# Model 2460 System SourceMeter®

## Version v1.3.0s Firmware Release Notes

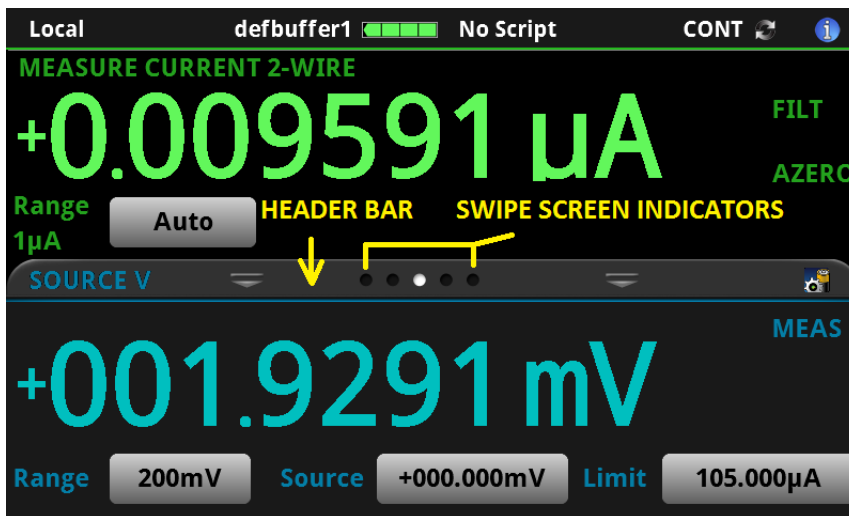
A number of improvements have been made to the overall Graphical User Interface as follows:

1. Screen Colors: All screen colors have been modified for better contrast and easier readability.
2. Pinch-to-Zoom Performance: Throughout the user interface, the “Pinch-to-zoom” touch screen motion has been improved and is more responsive.

3. Improve Swiping:
  - a. The swipe user interface gesturing has been dramatically improved and is more responsive.
  - b. Added Vertical Swiping in various screens in the GUI.

- c. Horizontal swiping has been made more smooth and is consistent with Vertical Swiping.
  - d. “Fling” swiping has been implemented where faster swiping actions result in rapid scrolling followed by decay based on the velocity of the “fling.”

- e. Swipe Down on the Home screen will display larger readings.
4. Tabs and Buttons: Throughout the user interface multiple data display options have been made available through tabs (header bars) with swipe screen indicators to show how many different display options are available and which display tab is active.

5. Graphing:
  - a. New Auto Scale Options (X-Axis) → Track Latest, Track Group
  - b. New Auto Scale Options (Y-Axis) → y-swim lanes, y-shared, y-per trace
  - c. Multi-Trace Line Plots
  - d. Multi-Trace Scatter Plots
  - e. Various refresh and performance improvements

6. Histogram:
  - a. New Auto-Scale, Auto-Bin, and Fit
  - b. Smartscale choose best scaling option
  - c. Various refresh and performance improvements
7. TTI Synchronization: All Touch, Test, Invent® Keithley Models including the 2450, 2460, and 7510 have been carefully updated so that they are all consistent in look, feel, and general navigation.
8. Updated Reading Table: Added new reading table features and a new Reading Preview Graph. Please see the Reference Manual for further details.
